**PLANNED UNIT DEVELOPMENT  
STAFF REPORT****Date: June 3, 2004**

**DEVELOPMENT NAME**      Fairfield Place Subdivision

**CONTEMPLATED USE**      Allow 47% site coverage, 20-foot front yard and five-foot sideyard setbacks in a R-1, Single-Family Residential subdivision

# SITE PLAN

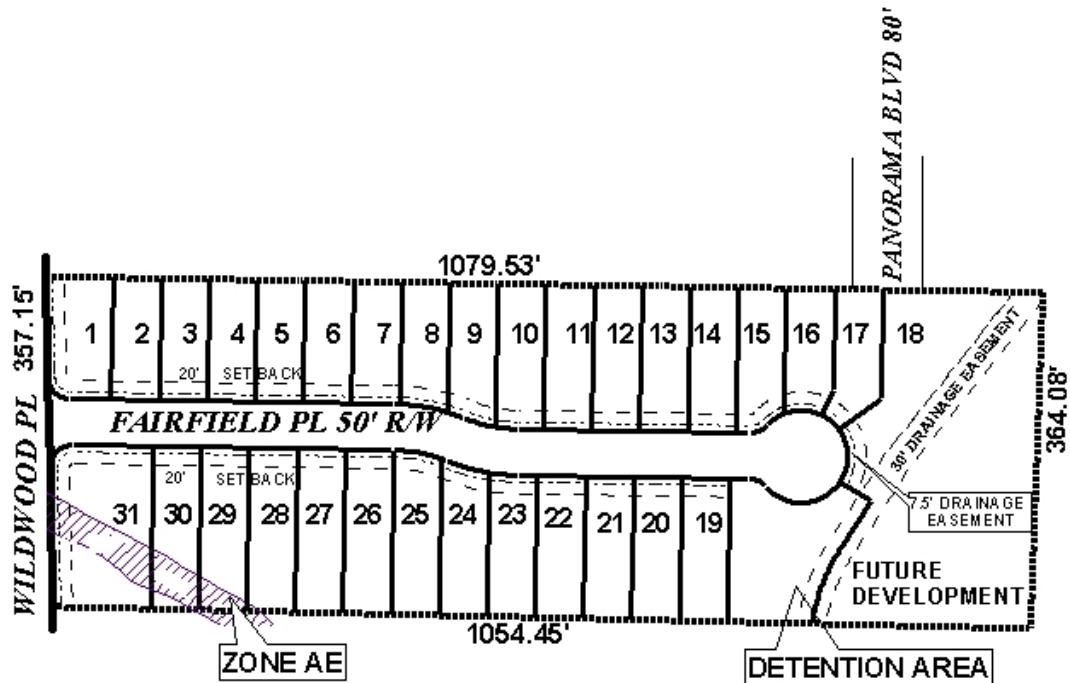
Applicant should provide a certified survey determining adequate stormwater system (including detention) was designed and constructed to accommodate increased coverage. Must comply with all stormwater and flood control ordinances. Any work performed in the right of way will require a right of way permit.

Property to be developed in compliance with state and local laws that pertain to tree preservation and protection on both city and private properties (State Act 61-929 and City Code Chapters 57 and 64). Preservation status is to be given to the 41" Live Oak Tree located on the South side of Lot 21. Any work on or under this tree is to be permitted and coordinated with Urban Forestry; removal to be permitted only in the case of disease or impending danger.

The reduced front yard setback (20-feet) and increased site coverage (47%) were approved by the Commission in December 2003. The applicant now proposes five-foot side yard setbacks, and the proposed side yard setbacks would maintain a minimum separation of 10-feet between structures, thus complying with prior Commission policy.

This application is recommended for approval subject to the following conditions: 1) submission of a certified survey determining adequate stormwater system (including detention) was designed and constructed to accommodate increased coverage; and 2) that the 41" Live Oak Tree located on the South side of Lot 21 be preserved—any work on or under this tree is to be permitted and coordinated with Urban Forestry, removal to be permitted only in the case of disease or impending danger.

## TYPICAL LOT DETAIL

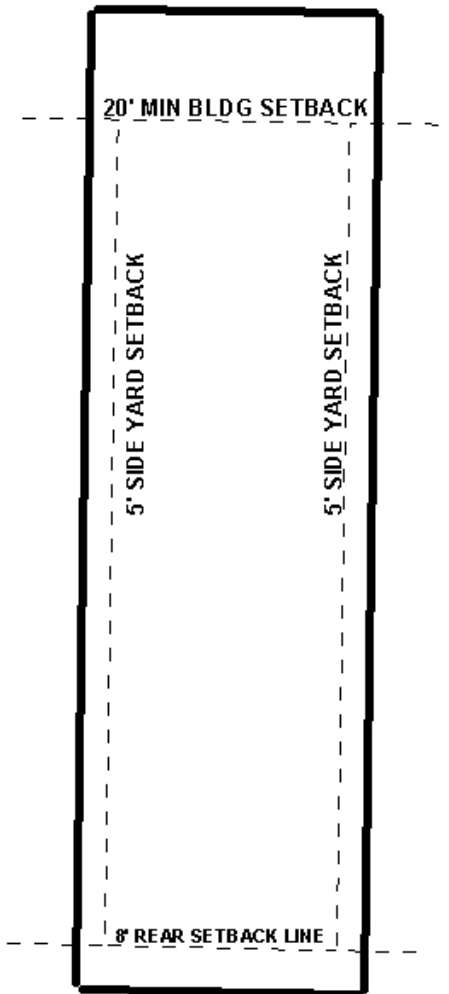
The applicant is requesting Planned Unit Development approval to allow reduced front (20-feet) and side yard (5-feet) setbacks and increased site coverage (45%). The site was granted PUD approval to allow increased site coverage and 20 foot front yard setbacks in December 2003; however, that application did not include a request for reduced side yards.
